Docket Item # 8
BAR CASE # 2015-0268

BAR Meeting
October 21, 2015

ISSUE: New Construction: Townhouses

LOCATION: 2 Duke Street

BUILDING 04 OVERALL ELEVATIONS

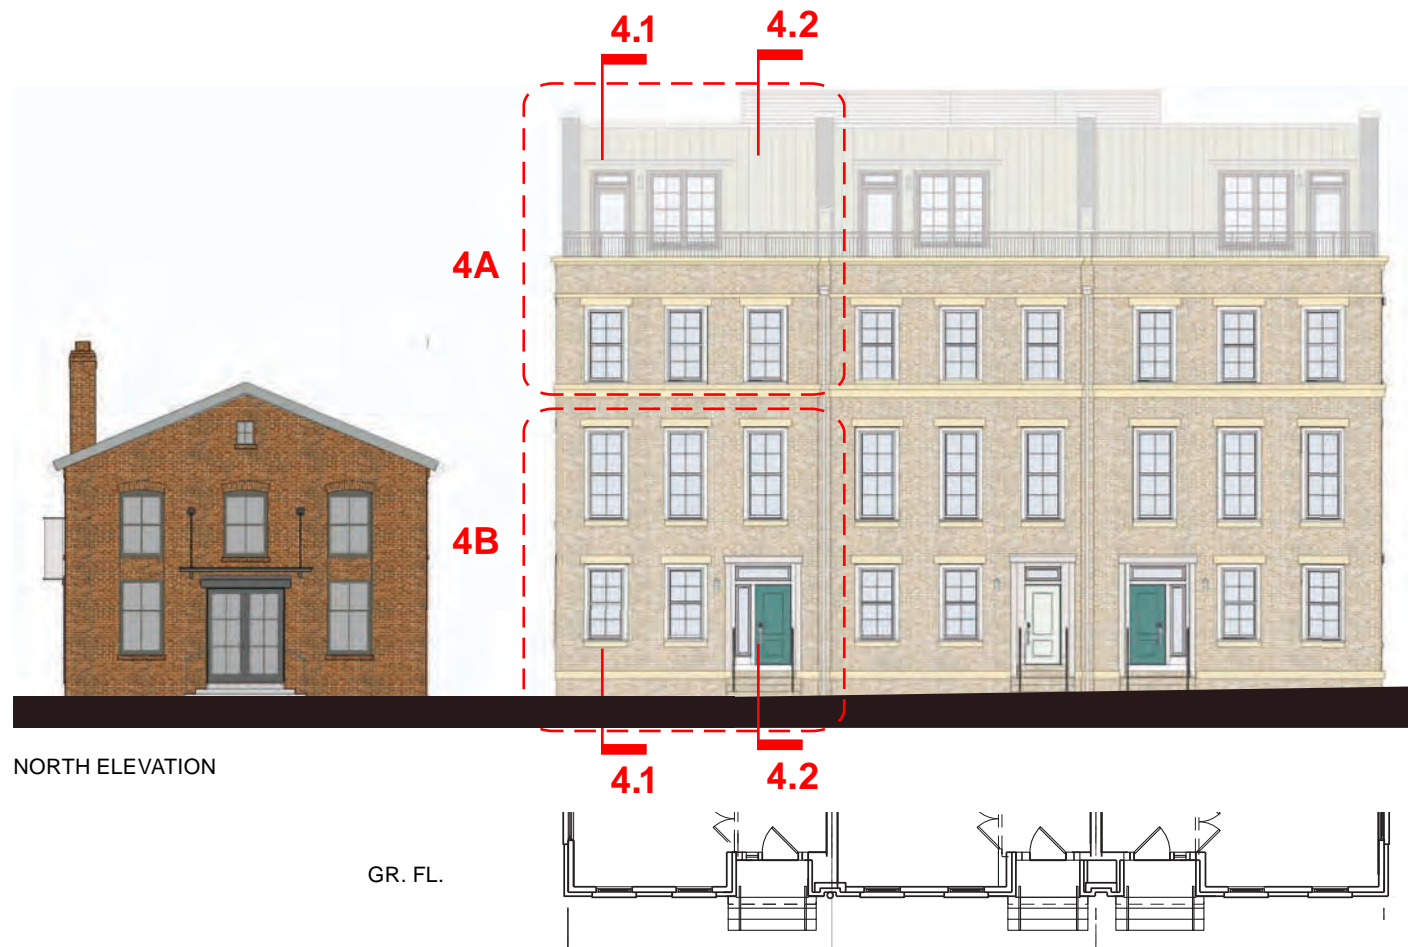
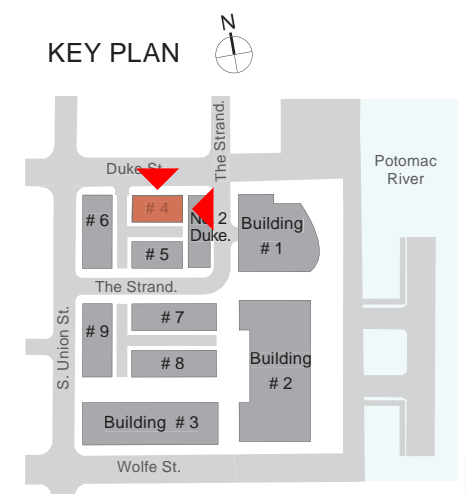
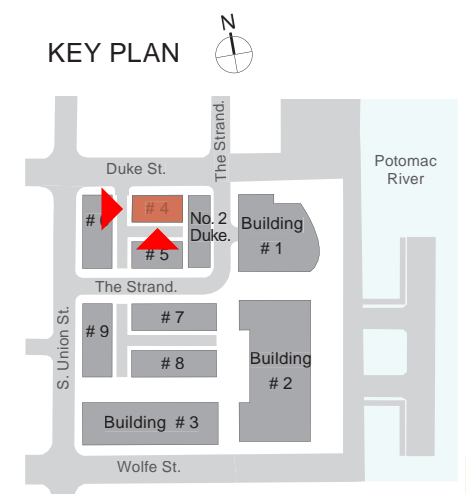
Although staff finds that these refinements are generally successful, it appears that the transition from the side to the rear elevations on Buildings 4 and 5 would benefit from some minor refinement (Sheets 14 and 17). The meeting point of the slate end wall and the rear standing seam metal is an abrupt location for a material change and this particular loft view is prominent above the roof of the historic 2 Duke Street warehouse. Staff recommends that the rear of Buildings 4 and 5 be treated the same as the ends and rear of Buildings 6, 8 and 9, where the slate on the ends wraps the corner around the rear elevation of the units at each end. Sheet 23 shows how this can be successfully executed. Therefore, staff recommends that approval be conditioned on working with staff on the final refinements of the rear transition at the fourth story of these two buildings as part of the permitting process.

That the applicant work with staff on the material transition at the rear of the fourth story loft at Buildings 4 and 5 and with a lighter colored slate on the east end of these buildings to be different from the color of the roof at the historic warehouse at 2 Duke Street, with final approval by staff as part of the building permit review process.

1. That the applicant work with staff on the material transition at the rear of the fourth story loft at Buildings 4 and 5, as directed by the BAR, with final approval by staff as part of the building permit review process.
